Concerns with Priority Assertion Signal Based DTBS

Presented by
Rick White
Motorola
Wireless Data Group

Priority Assertion Signal Impacts on CCA

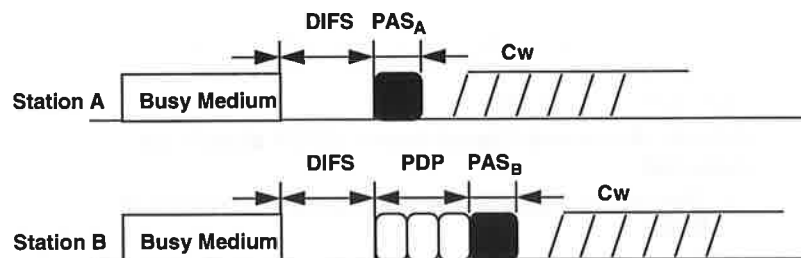
- Priority Assertion Signal (PAS) is not a complete frame. May be some or all of the radio preamble.
- Detection of PAS could be different than detection of normal frame (Radio Preamble).
- Detection of PAS should be reliable in presences of collision.
- Probability of collision is higher for PAS than a normal frame.
- CCA is required to detect both PAS and Radio Preamble at any point in time.
- A PAS could collide with a frame.
